License Nos. DPR-39, DPR-47 and DPR-55  
Appl for Amend: tech specs proposed change  
concerning computer software currently  
used to process the incore detector signal..  
..notorized 1/3/78.....

PLANT NAME: Oconee Units 1-2-3  
RJL 1/6/78

Re: Oconee Units 1, 2, and 3  
Docket Nos. 50-269, -270, -287

PROTECTIVE SYSTEM MAXIMUM  
ALLOWABLE SETPOINTS  
UNIT 2

Figure 2.3-2B

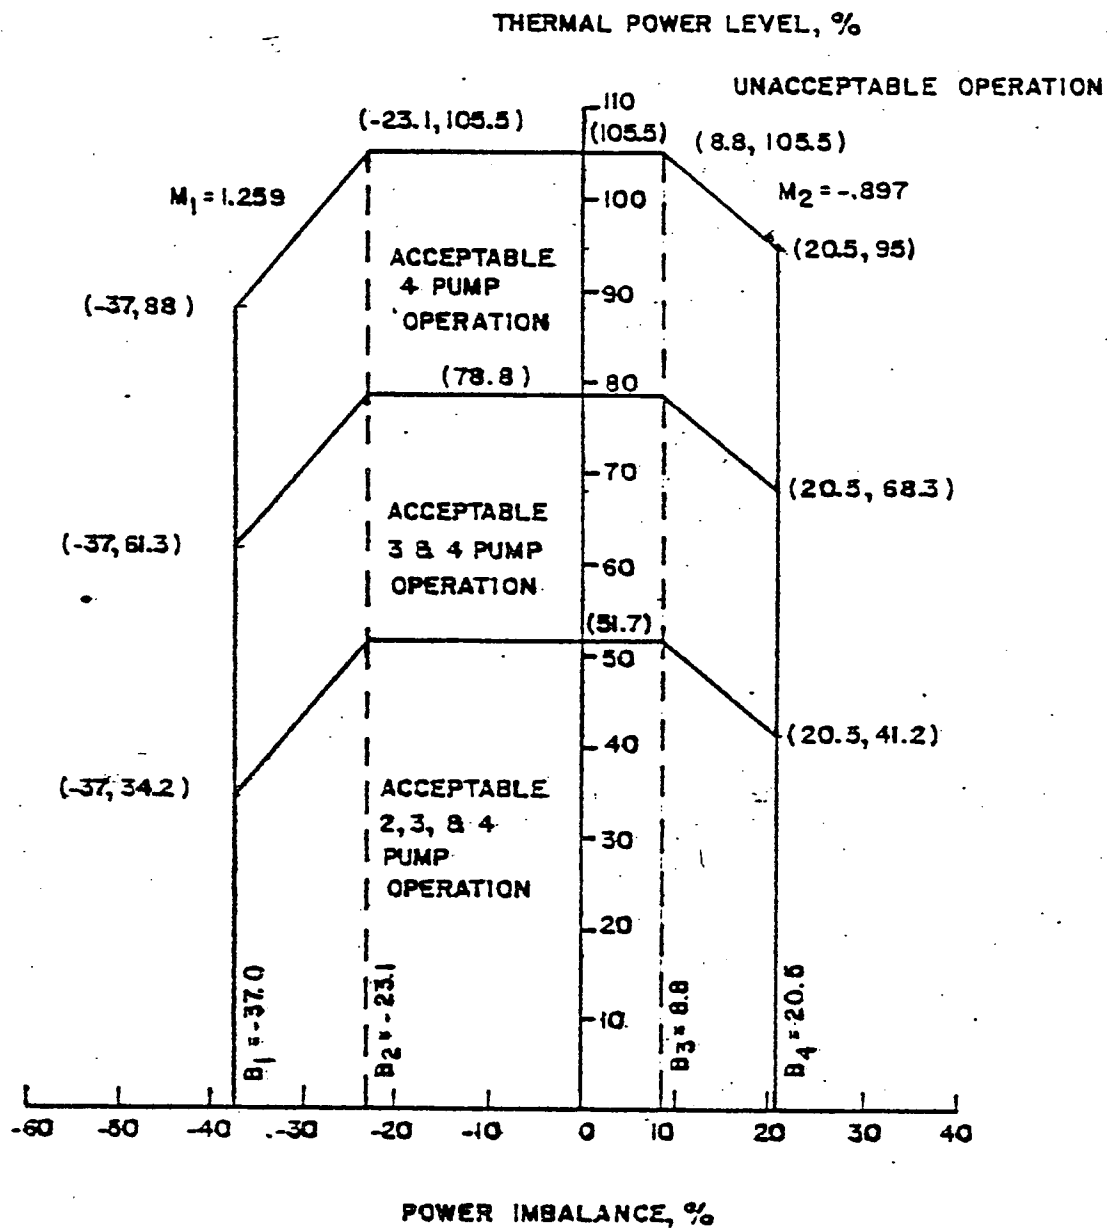
computer software is corrected for the proper background signal processing. Therefore, a revision of the Oconee Nuclear Station Technical Specifications is proposed herein pursuant to 10CFR §50.90. The attached proposed revision includes the modified power-imbalance trip setpoints for Oconee 2 and 3 (Technical Specification Figures 2.3-2 B and C) in order to account for the bias in the positive imbalance measured by the current incore detector system.
